OSSF Inspection Sheet

Permit of Authorization to Construct an On-Site Sewage Facility Permit Valid For One Year From Date Issued

Permit Number: 117336
Issued This Date: 04/15/2024
This permit is hereby given to: MICHAEL WITT

622 SYCAMORE FALLS
CANYON LAKE, TX 78133

DZ1500LP
3- COMPARTMENT
SEPTIC / SEPTIC /
PUMP TANK

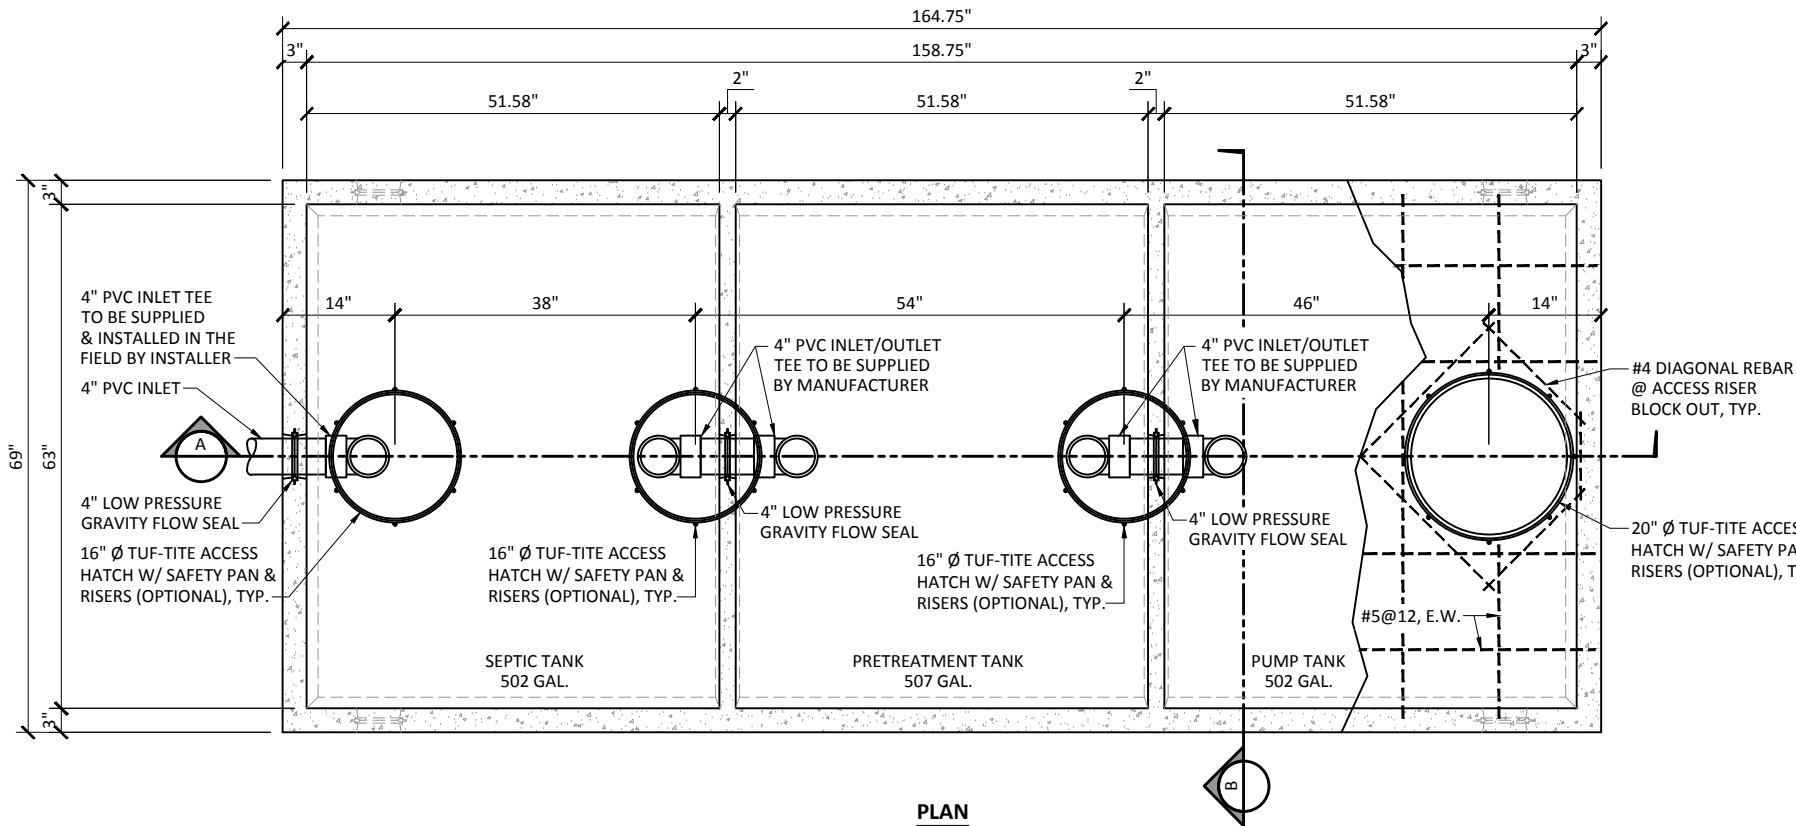
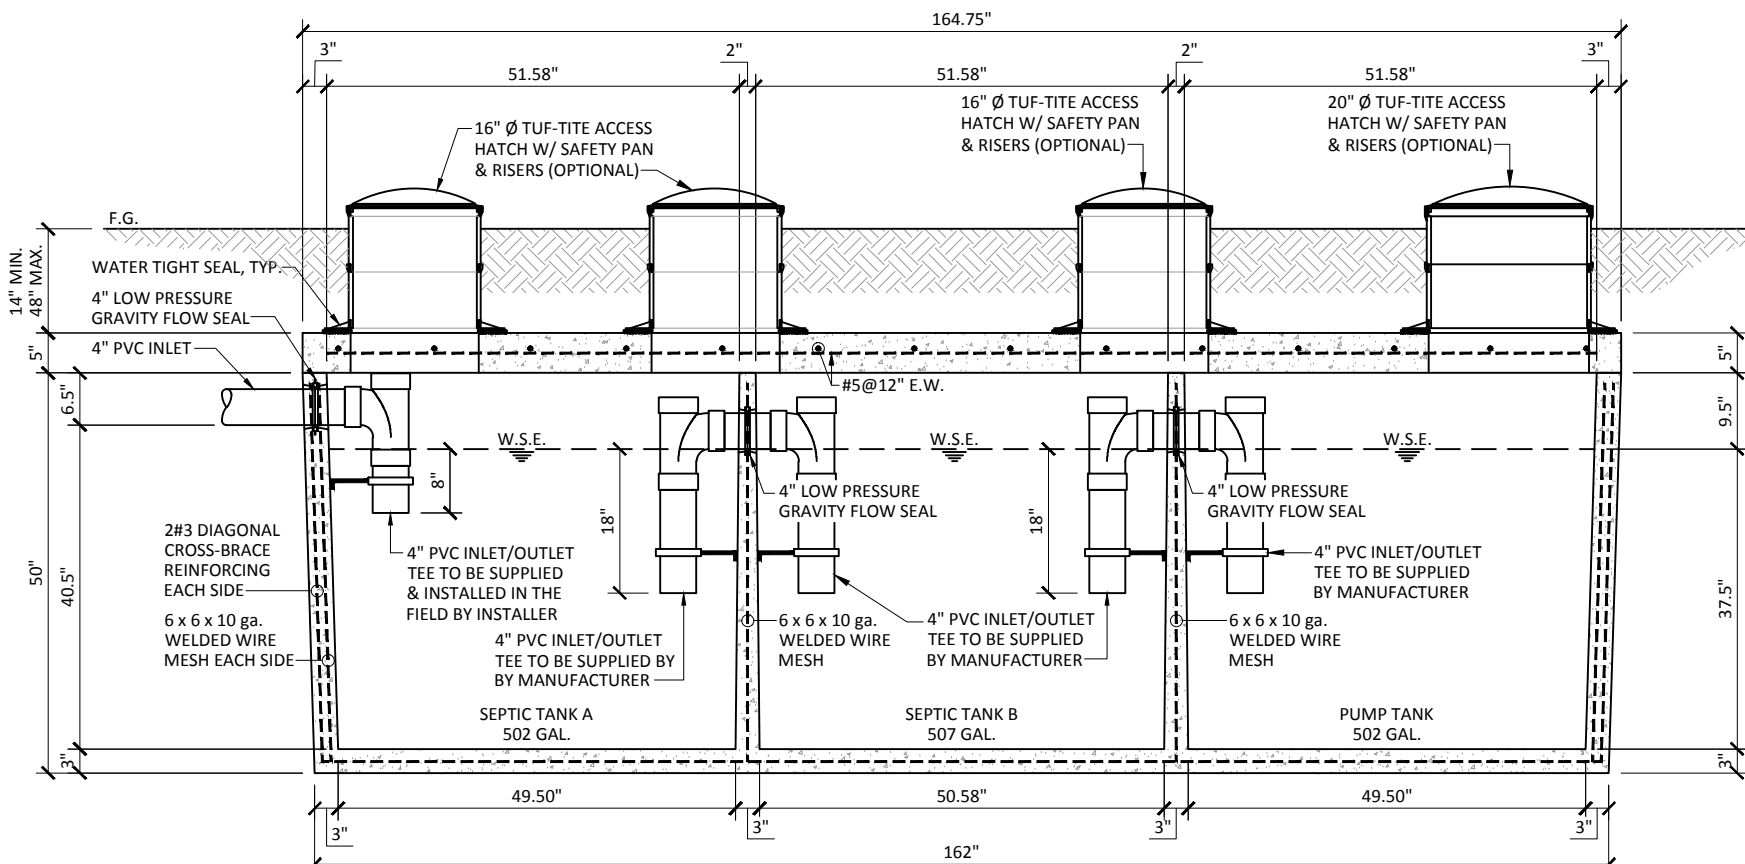
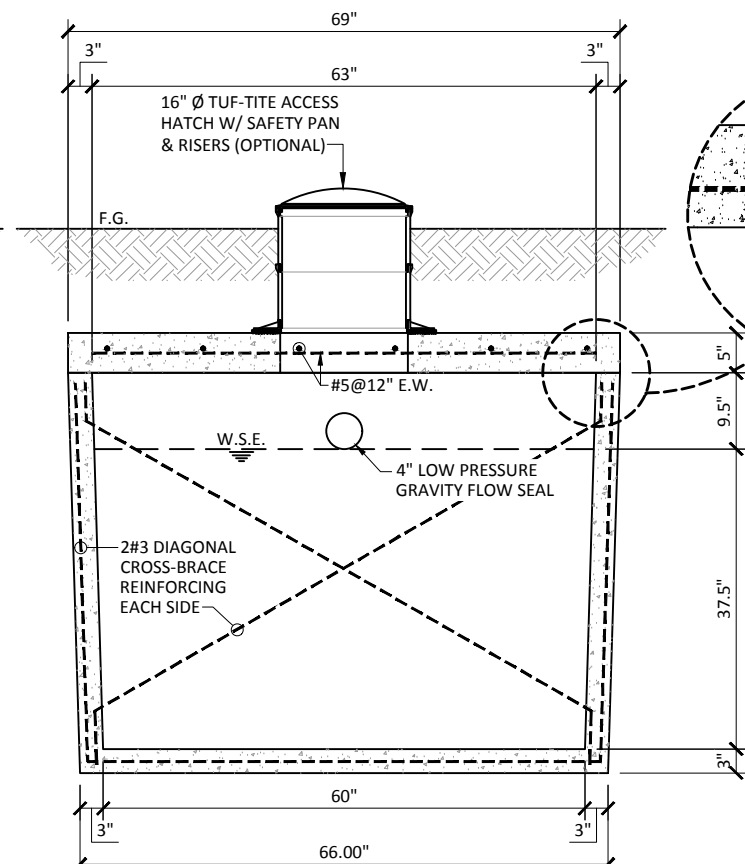
1. Show a cross section of the entire tank.

TYPICAL PUMP TANK CONFIGURATION
500 GAL 3RD COMP. OF
1500 GAL 3 COMP.

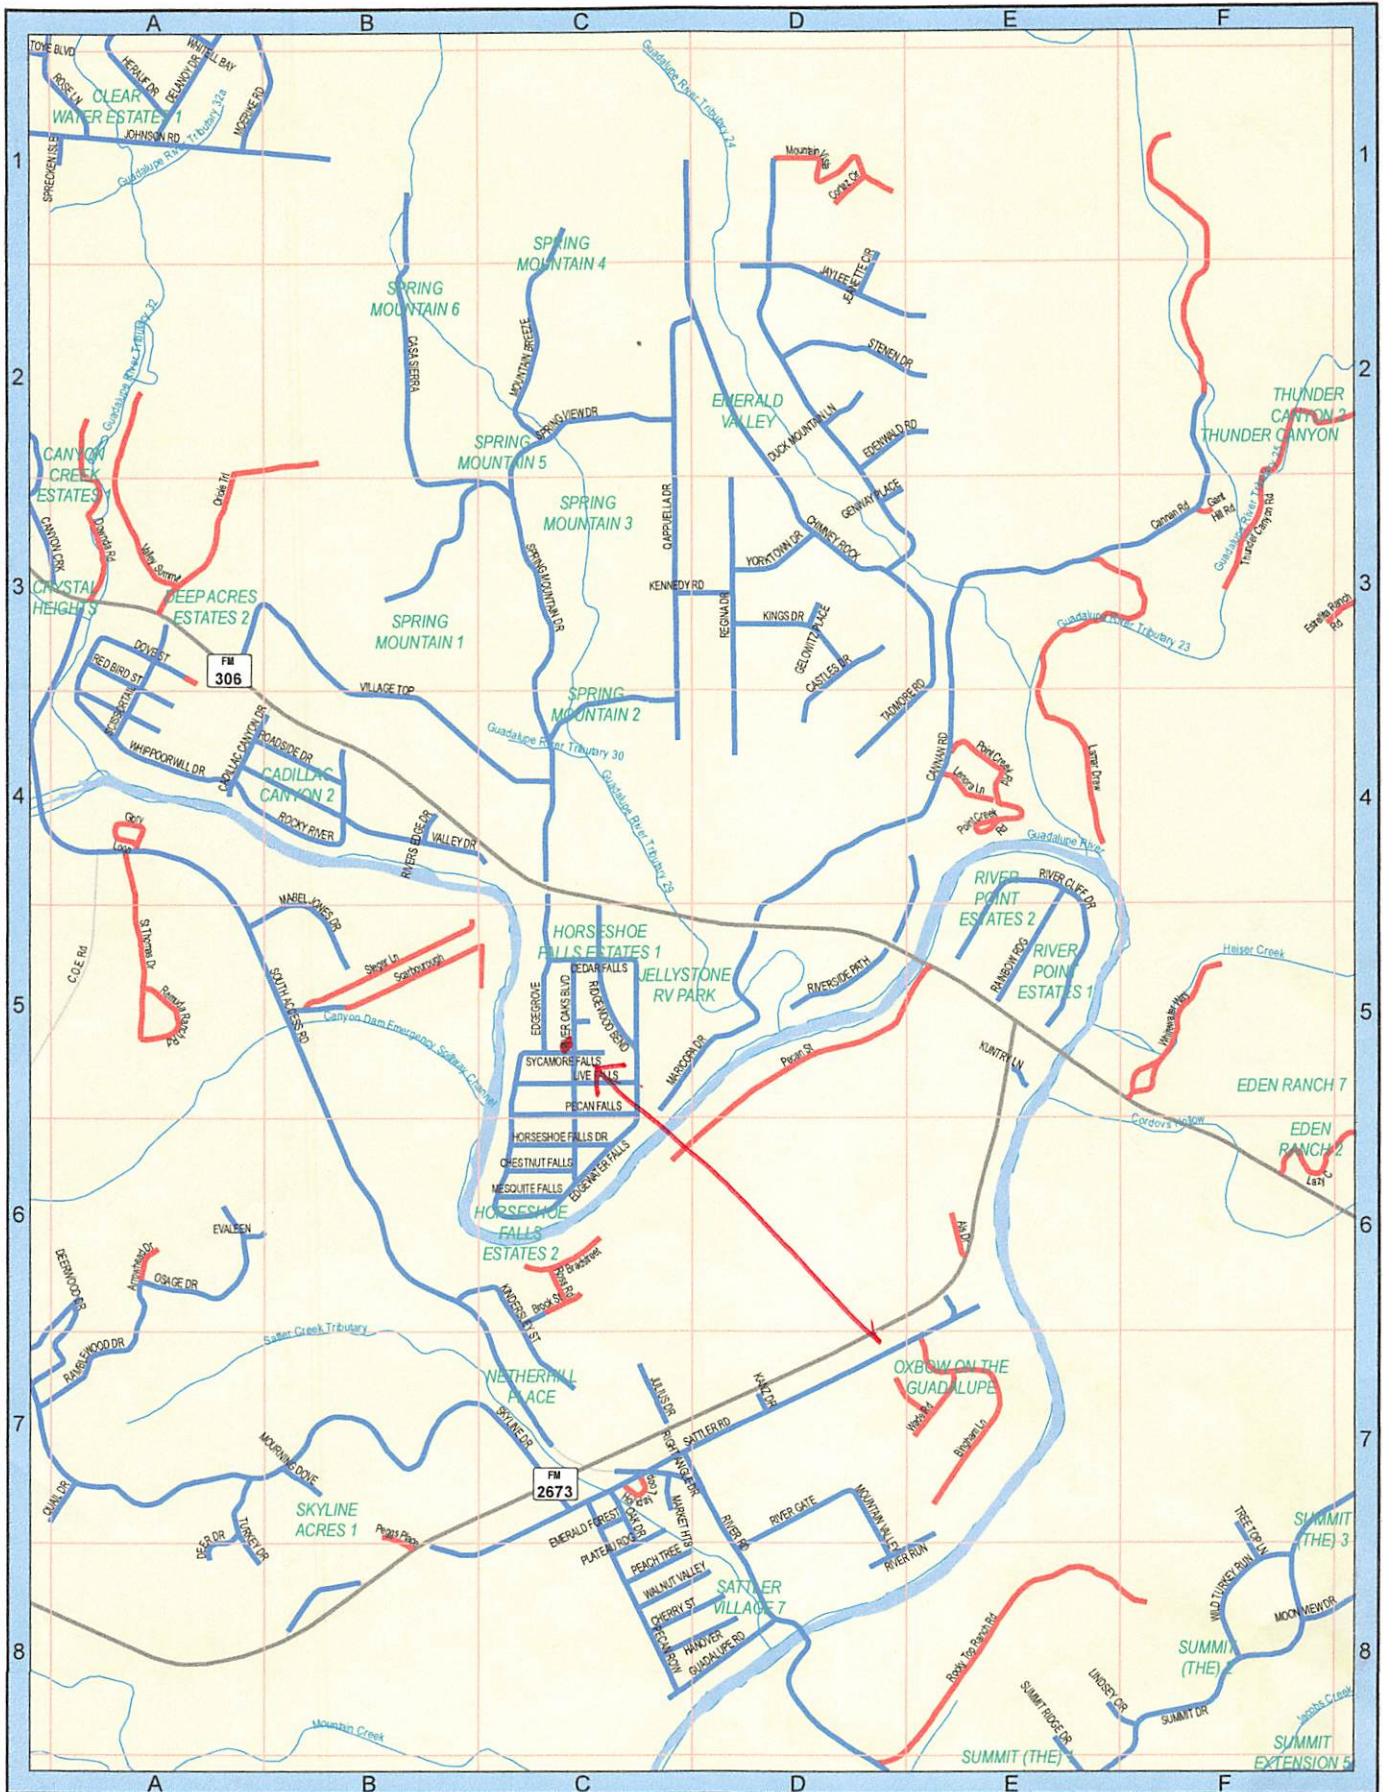
2. Include the use of an audible and visual alarm in the planning materials

REVISED TO ADD PUMP CHAMBER DUE TO STUBOUT DEPTH.
THX,
GREG
